RE: **Chipotle**
4930 Pan American Fwy NE
Grading and Drainage Plan
Engineer's Stamp Date: 9/25/2018
Hydrology File: F17D101

Based on the submittal received on 10/1/18, the Grading and Drainage Plan cannot be approved for Grading or Building Permit until the following corrections are made:

Grading Plan

C
201

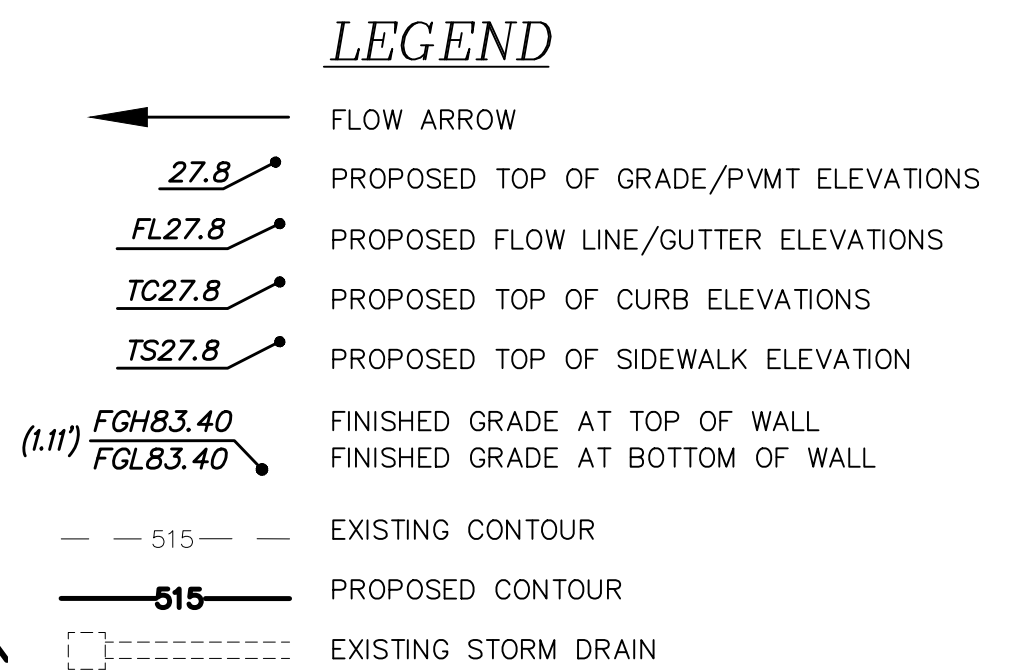
1. For trash enclosures serving food service developments, demonstrate control of liquids from dumpster areas per DPM Chapter 22.9.E, Table 1 by containing runoff from the dumpster area and discharging to the sanitary sewer. If this information is on the utility plan please provide it, or show on the grading plan.

2. Quantify the additional impervious area and new first flush volume being generated by this project.
3. A portion of this project is located in a floodplain (AO-1') and a floodplain permit must be obtained. Please contact Rudy Rael, CFM for more information regarding floodplain permits (RRael@cabq.gov).

4. How much fill/cut is being placed in the floodplain?
5. For Information. Hydrology and Transportation files are available online through the City's GIS Viewer 2.0: <https://www.cabq.gov/gis/advanced-map-viewer>. Turn on the *HydroTrans* layer: *Operational Layers > Albuquerque Layers > Sites > HydroTrans*. Select the desired polygon from the map and click *Link to Project Documents*.
